# UNITED STATES PATENT AND TRADEMARK OFFICE

10/509,683

Eigoro Yamanouchi

<b>Office Action Summary</b>	<b>Application No.</b> 10/509,683	<b>Applicant(s)</b> YAMANOUCHI, EIGORO	
	<b>Examiner</b> Lindsey Bachman	<b>Art Unit</b> 3734

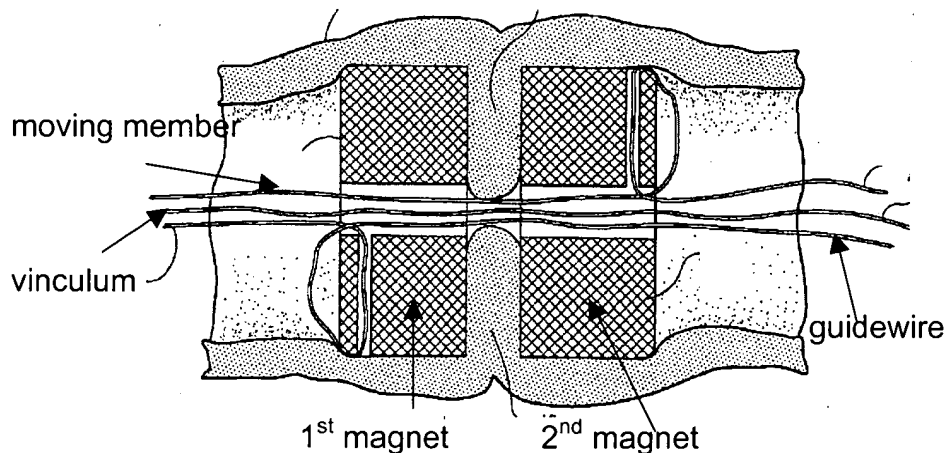
4. Claims 1 and 9: Rudakov'966 discloses an anastomosing device containing a flexible guidewire, a first magnet formed in a disc shape and provided with a radial through hole in order to place a guidewire, a vinculum secured through the center of the first magnet, and second magnet with a through hole and a moving member for moving the magnets. See the labeled figure below.

5. Claim 5: The device taught by Rudakov'966 has chamfered corners (see Figure).
